4" ASPHALT REPLACEMENT
(122,201 SF)

FULL SITE
1"=100'

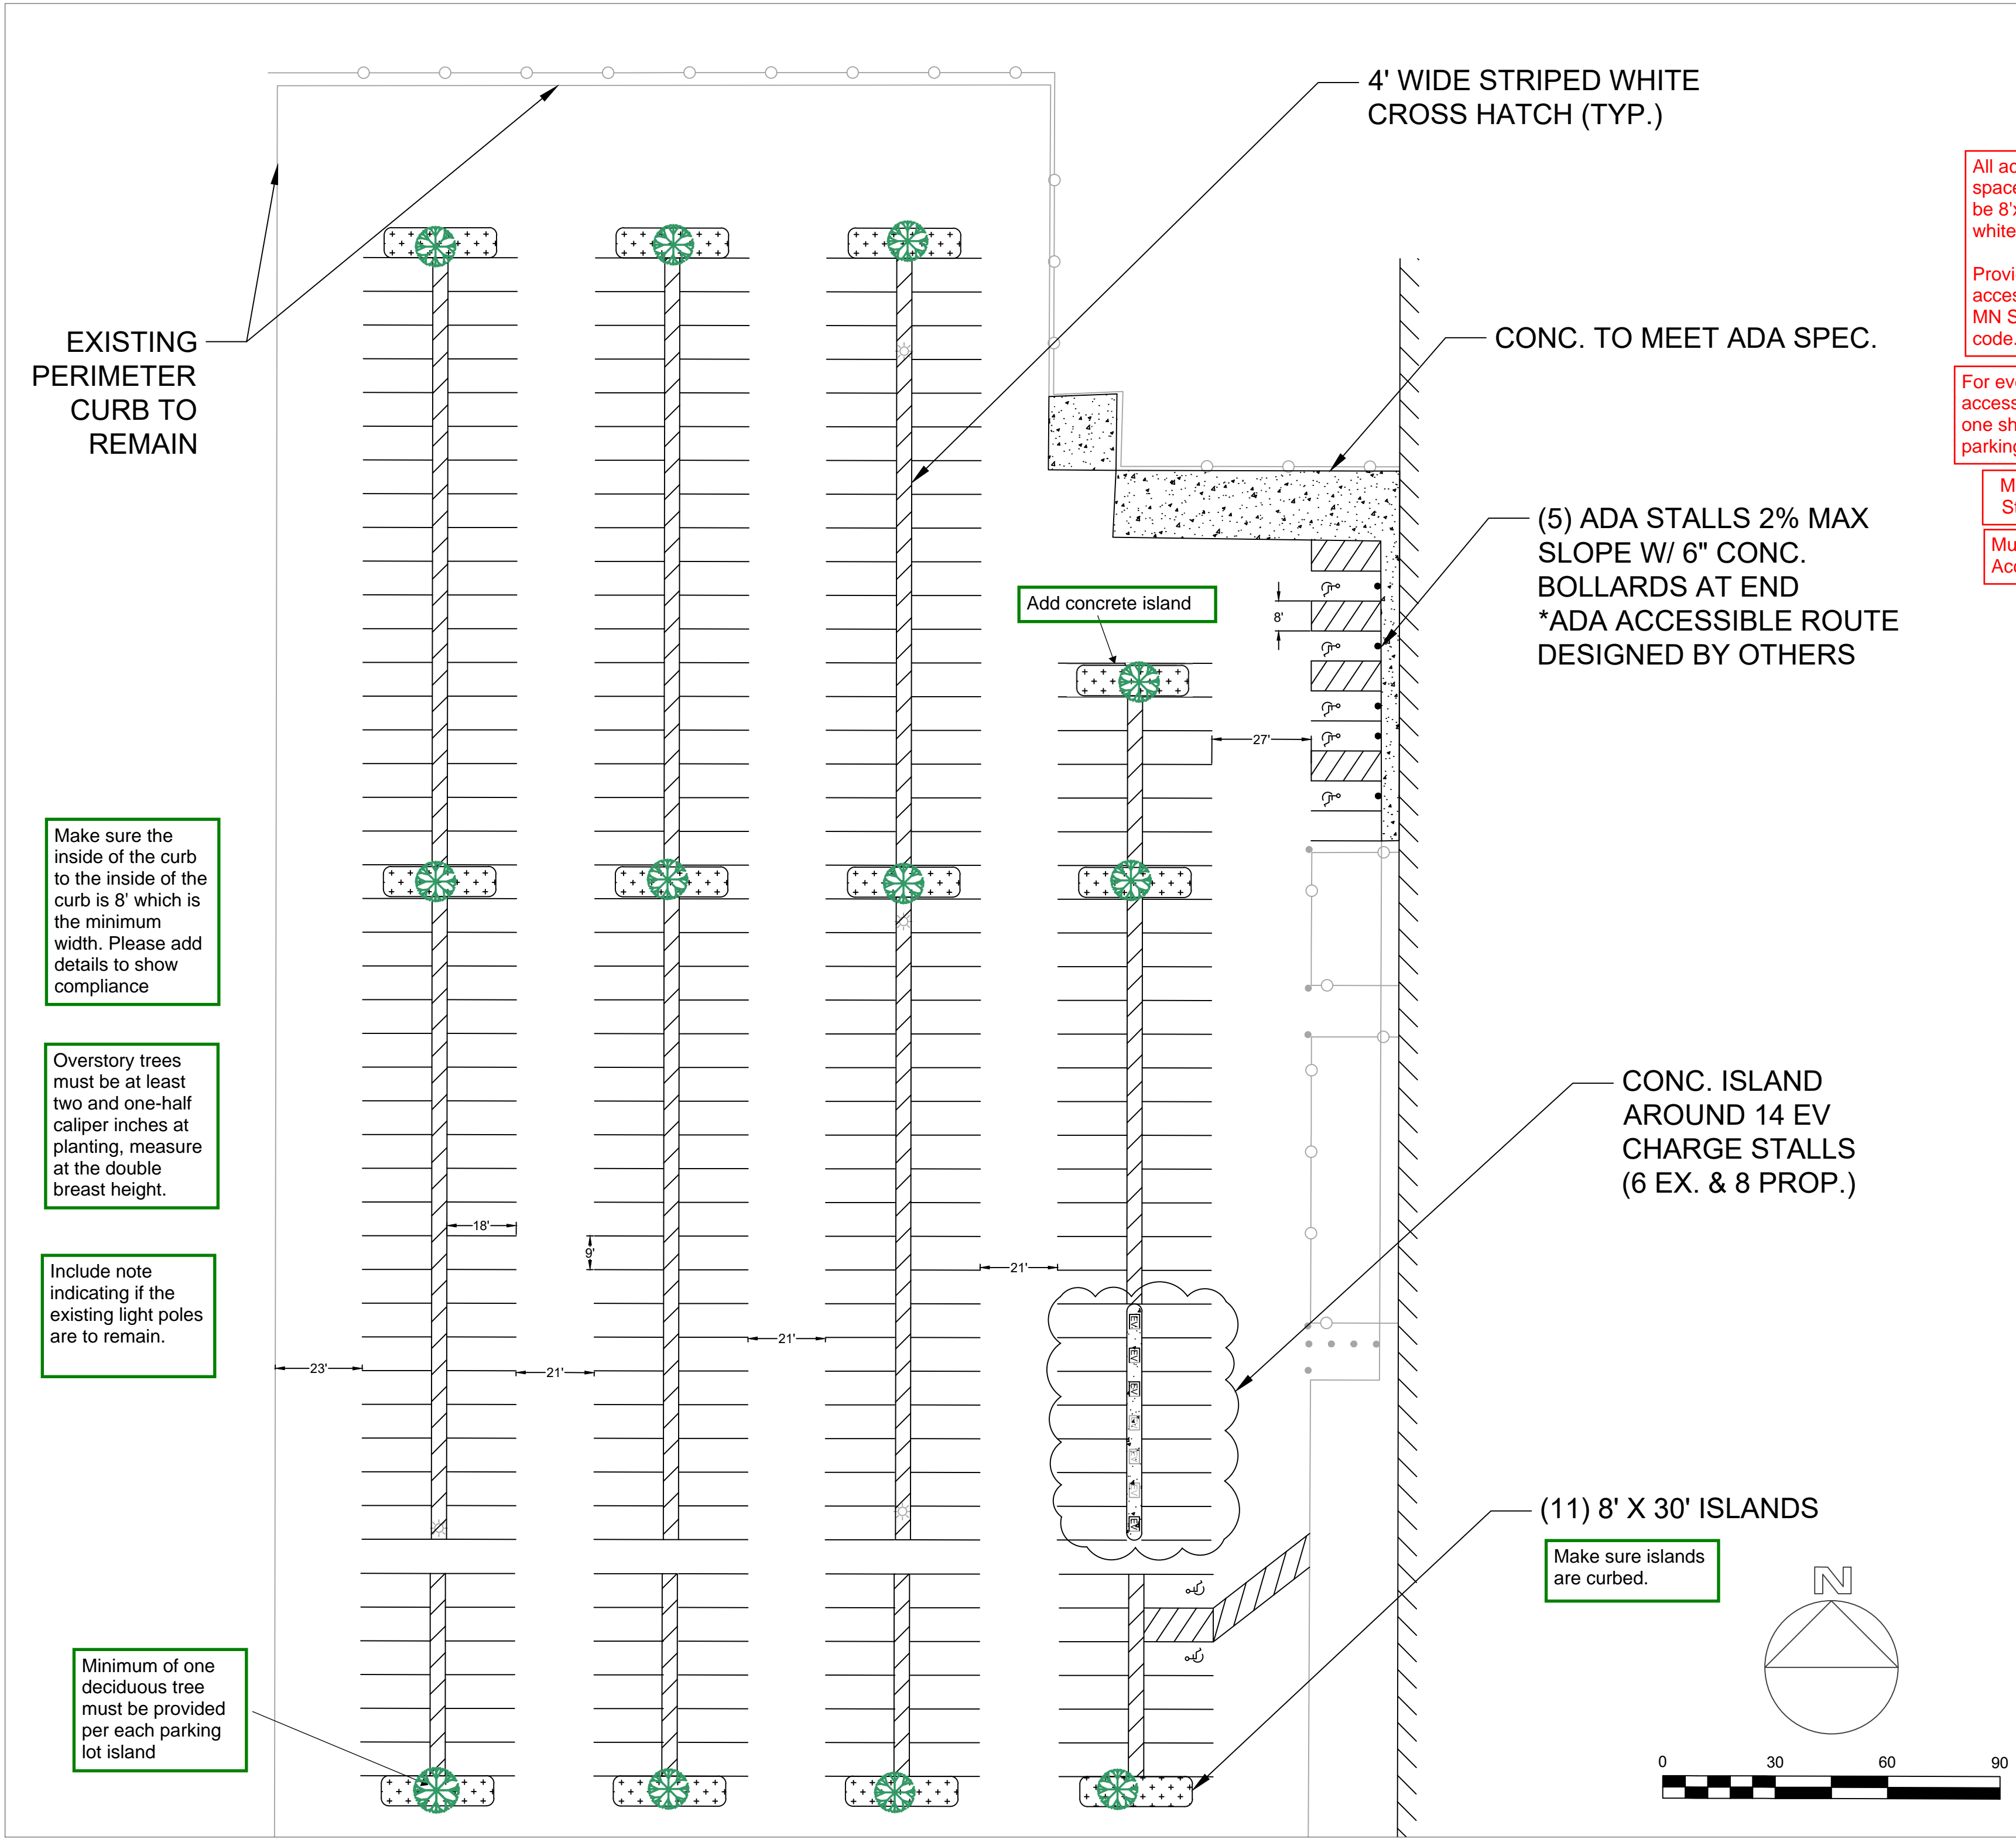
Maintain emergency vehicle access and circulation throughout the property.

Ensure landscaping doesn't interfere with access to the building, hydrants and/or FDC.

Show existing storm sewer on plans.

Show proposed modifications to existing storm sewer on plans.

Show inlet protection locations on plans.

All accessible parking spaces for public use shall be 8'x18' and striped in white.

Provide required accessible stalls per 2020 MN State Accessibility code.

For every 6 or fraction of 6 accessible spaces, at least one shall be a van-accessible parking space.

Must meet 2020 MN State Building Code

Must meet 2020 MN Accessibility Code.

Make sure the inside of the curb to the inside of the curb is 8' which is the minimum width. Please add details to show compliance

Overstory trees must be at least two and one-half caliper inches at planting, measure at the double breast height.

Include note indicating if the existing light poles are to remain.

Minimum of one deciduous tree must be provided per each parking lot island

Make sure islands are curbed.
